Randwick Local Planning Panel (Public) Meeting

Development Application Report No. D1/23

Subject: 169 Rainbow Street, Randwick (DA/424/2022)

Proposal:	Alterations and additions to the existing dwelling house including new rear roofed patio with subfloor storage area and associated works.
Ward:	East Ward
Applicant:	Mr J Spiteri
Owner:	Mr M A Archer & Ms C Christian
Cost of works:	\$165,000
Reason for referral:	More than 10 unique submissions by way of objection were received

Figure 1. Proposed site plan – 169 Rainbow Street, Randwick

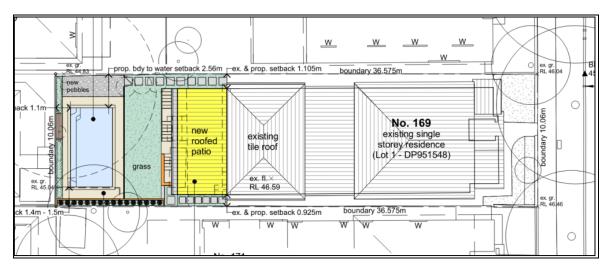
Amended plans were received on 24 October 2022, with revisions to the proposed deep soil area.

Note: The development application does not include the proposed pool and associated retaining walls and landscape works. As notated on the proposed plans, these works are subject to a separate Complying Development Certificate application.

Certificate which clearly identifies the proposed works only and deletes all references to the swimming pool and associated works. The Construction Certificate plans should note that the swimming pool is under a separate development consent.
